## SMARTSTARTIII INSTALLATION ADDENDUM FOR CRUISAIR STQ, SQUF & SQL SYSTEMS WITH REV B Q-RELAY (SHIPPED 9/2009-7/2010)

SMARTSTARTIII INSTALLATION ADDENDUM FOR CRUISAIR STQ/SQUF SYSTEMS W/ REV B Q-RELAY, 115-240V/50-60HZ/16

PART NUMBER: 0880306

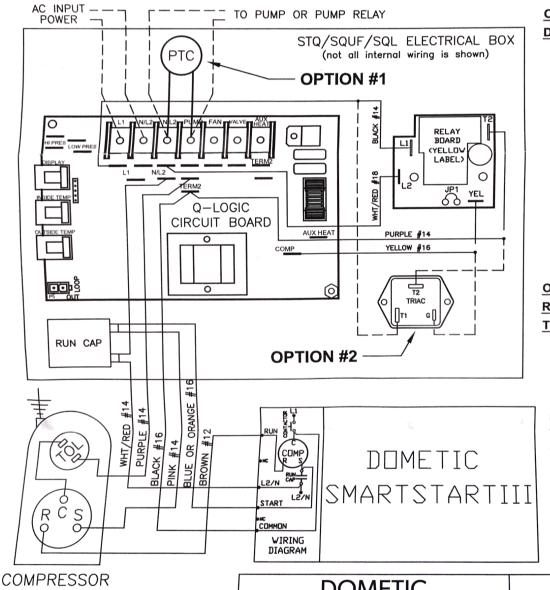
FOR STQ, SQUF, & SQL SYSTEMS SHIPPED FROM 11/2009 THROUGH 7/2010, THE REV B Q-RELAY BOARD (YELLOW LABEL) USED IN THE ELECTRIC BOX IS NOT COMPATIBLE WITH THE SMARTSTART. THERE ARE TWO REMEDY OPTIONS DESCRIBED HERE TO RESOLVE THIS. FOR SYSTEMS SHIPPED AFTER 7/2010, A NEW REV C Q-RELAY BOARD (BLUE LABEL) WILL BE USED WHICH IS COMPATIBLE WITH THE SMARTSTART AND DOES NOT REQUIRE APPLICATION OF EITHER OF THESE REMEDIES.

## **OPTION #1 - INSTALL PTC LOADING DEVICE (DOMETIC P/N 4220046):**

THIS DEVICE MUST BE PURCHASED SEPARATELY. INSTALL THE PTC LOADING DEVICE ACROSS THE PUMP L1 AND PUMP L2 TERMINALS ON THE Q-LOGIC CIRCUIT BOARD TERMINAL STRIP. THE PTC CAN REACH HIGH TEMPERATURES. SO POSITION IT TO INSURE THAT IT DOES NOT COME IN CONTACT WITH ANY WIRES OR THE INSIDE OF THE ELECTRICAL BOX PLASTIC COVER.

## **OPTION #2 - REPLACE THE Q-RELAY REV B BOARD WITH COMPRESSOR** TRIAC (DOMETIC P/N A-548):

THIS DEVICE MUST BE PURCHASED SEPARATELY. DISCONNECT THE WIRES FROM THE Q-RELAY BOARD. REMOVE IT AND ITS MOUNTING HARDWARE, AND INSTALL THE TRIAC IN ITS PLACE ON THE STUDS USING THERMAL COMPOUND AND TWO #4-40 NUTS. RECONNECT THE T1.T2 & GATE WIRES PER THE WIRING DIAGRAM. THE L2 WIRE IS NOT REQUIRED FOR THE TRIAC AND CAN BE DISCARDED.
